Subject: Same old road drainage early morning ramblings

Same Old Road Drainage Restoration Project Segments 1, 2 & 3

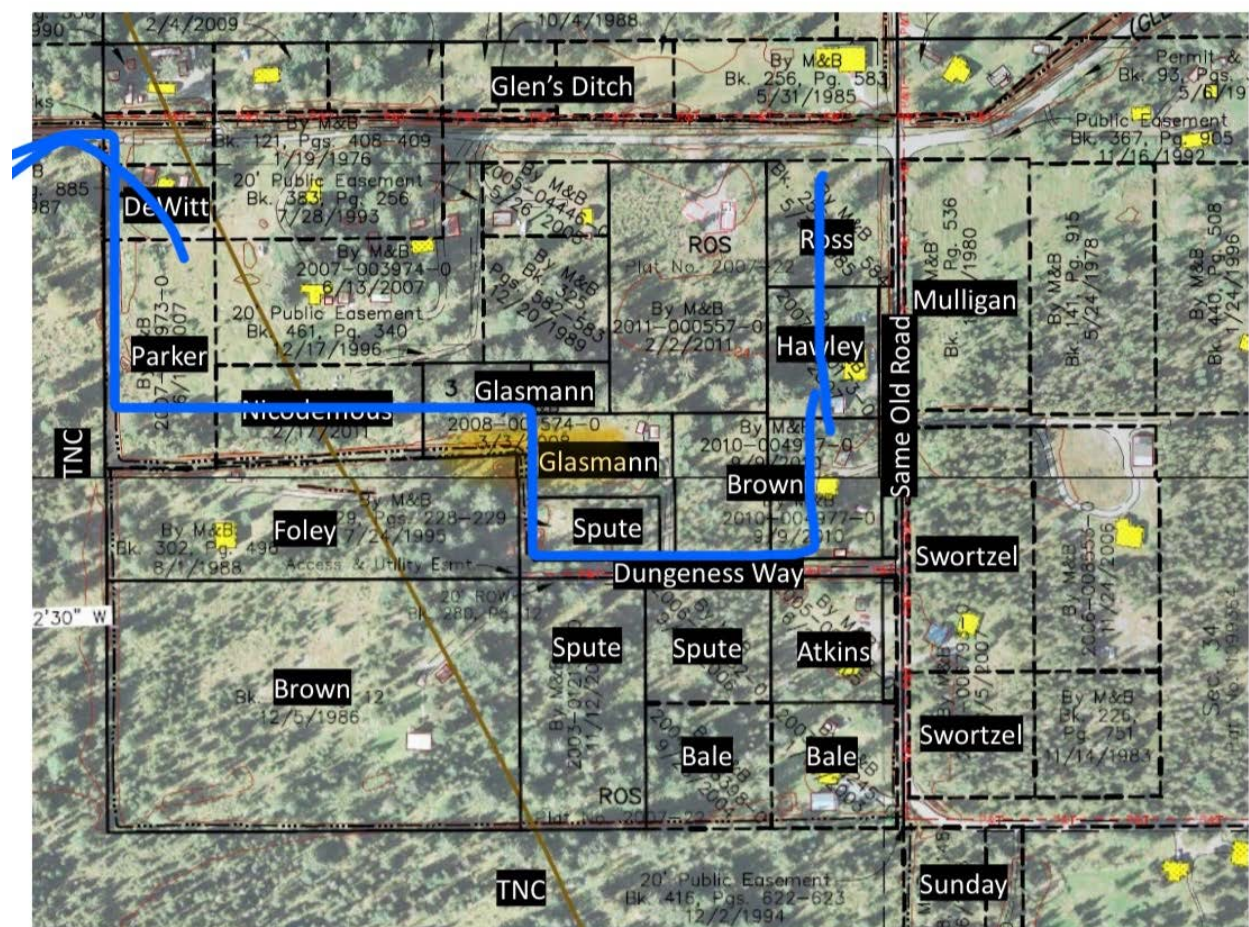
Hybrid of proposed segments 1,2,3, roughly illustrated in blue:

Would need property owner buy in, some survey work, and recon of utilities to see if it's feasible. There will be surprises. This would be beneficial to a number of road users and perhaps be accepted by surrounding land owners. No PFAS spreading that we know of. More material hauling would be necessary. Glens Ditch from Dewitts S would benefit from a cleaning.

Inside the red circle, S of the Barry to Sunday ditch, there is evidence of the old natural drainage. Again, not well illustrated and bears further investigation. I can help with that. LiDAR data is available, maybe John or Witney has something that could import the raw data. It is evident when zoomed in on and/or looked at in person. It was blocked with spoil when homestead ditch that leads from Barry subdivision headed W towards Sunday's was put in. It could be opened back up with less visible mayhem than TNC has already agreed to on proposed segment 1. It is a natural drainage, not man made.

E/W ditches are reservoirs and should be minimized wherever possible. In most cases, they hold water that builds, eventually relieving towards the S when the level is high enough. In my experience, the natural grade S in Gustavus averages .1% which is 6 inches

for 500 feet more or less. Not much. We can't do a thing about physics and it's pricey to change the topography.
